05.1-33

TECHNICAL BULLETIN

**Incorrect Emission Control Label –
Install Revised Label – Canadian Vehicles
Service Action S691**

MODEL 1995 MY
XJR
VIN 720001-754303

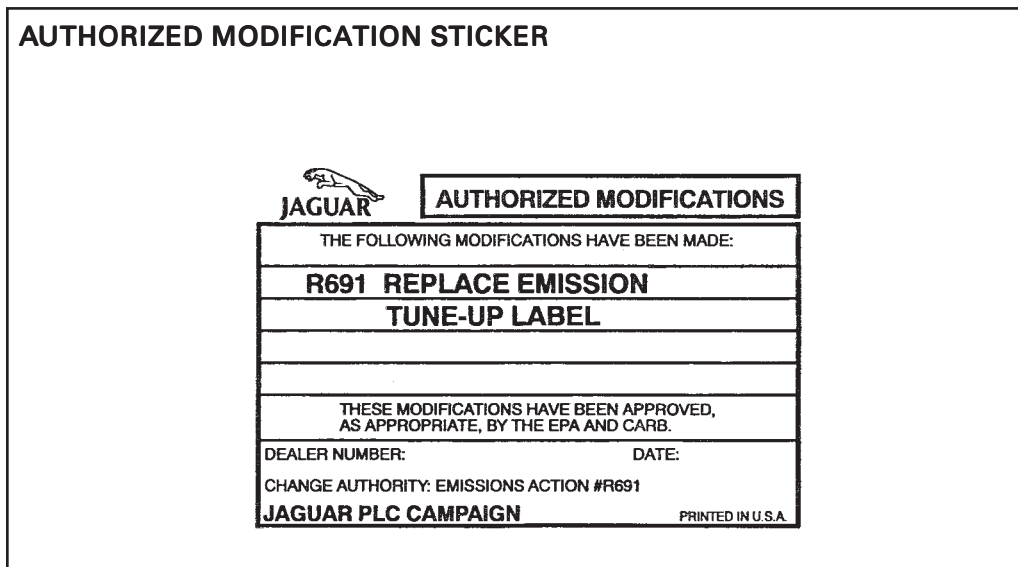
On all 1995 Model Year XJR Sedan Models within the above VIN range, the factory-installed Emission Control Data Label (“Tune-up Label”) was incorrectly specified. This label is applied to the crossmember above the radiator, within the engine compartment. 1995 MY XJ6 4.0L Sedan models with naturally-aspirated AJ16 engines are NOT affected.

The existing label implies that the engine is equipped with an Exhaust Gas Recirculation system which is not the case.

LOCATION OF EMISSION CONTROL DATA LABEL

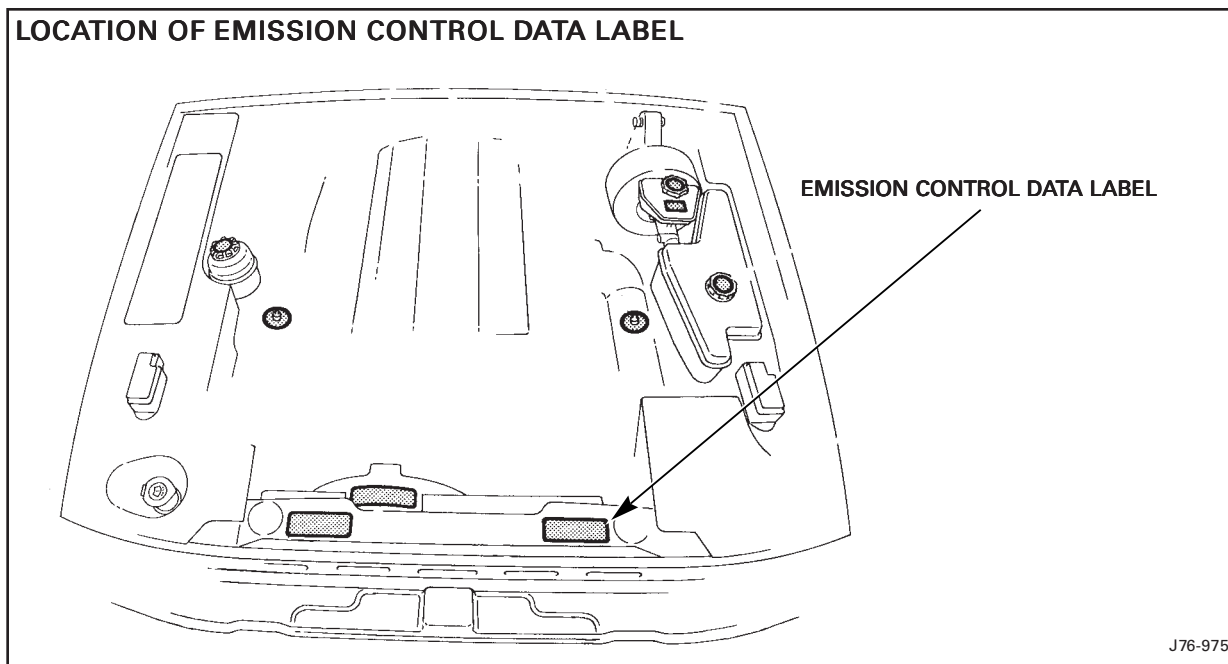
2. Identify the Emission Control Data Label ("Tune-up Label"), located on the left side of the cross panel above the radiator (Illustration 2).
3. Clean off the existing label.
4. Apply the replacement label over the old label.
5. Apply an R691 authorized modification label to the Driver side B-pillar. (This label will immediately indicate to any other Dealer that the vehicle concerned has already been rectified).
